Private Plan Change – Second Request for Information under Clause 23 of Schedule 1 of the RMA

Applicant:	Fletcher Residential Limited
Address:	79 Ladies Mile, Remuera

Appendix 1 – Clause 23 Request for Information

Appendix 2 –Suggested Changes to Precinct Provisions

IXXX.10.2 Remuera Precinct Plan 2— Open Space & Features

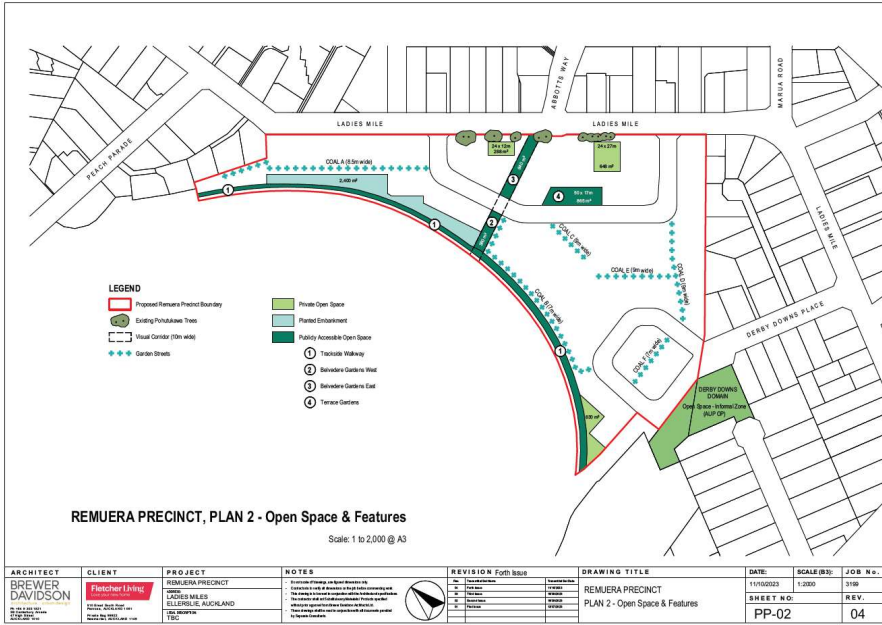
Commented [DK49]: Suggested that Tree #13 is clearly identified on this plan so it is clear that the precinct provisions do not apply to it and that the Notable Tree provisions are used

IXXX10.3 Remuera Precinct Plan 3-Movement

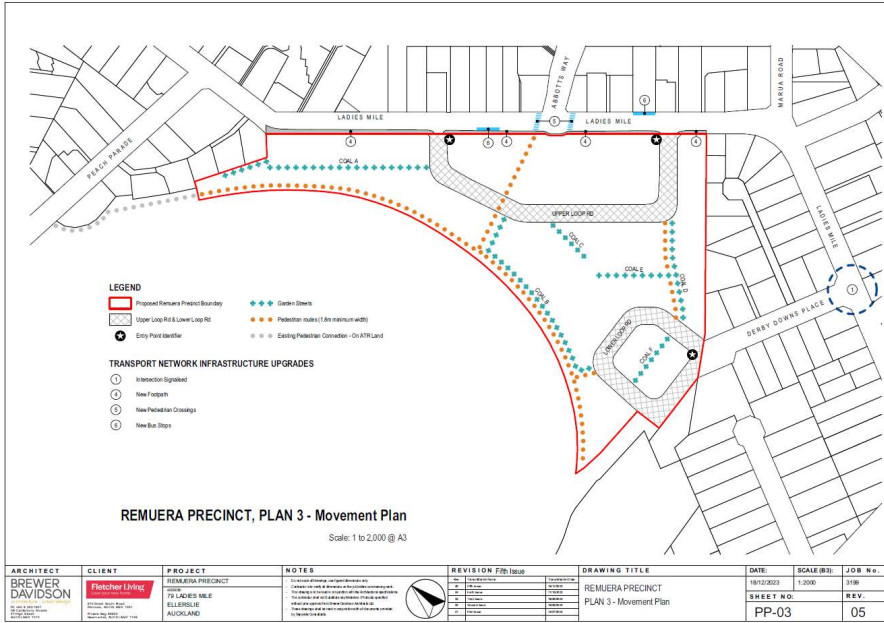
Commented [DK50]: Consider how pedestrian routes that are over COALs are to be ensured as public if development plans for the site were to fall over, and the easements in gross for the underlying subdivision were not for some reason carried through. Nothing on here indicates that they are for public use. Could be labelled as "Publicly Accessible Pedestrian Paths"
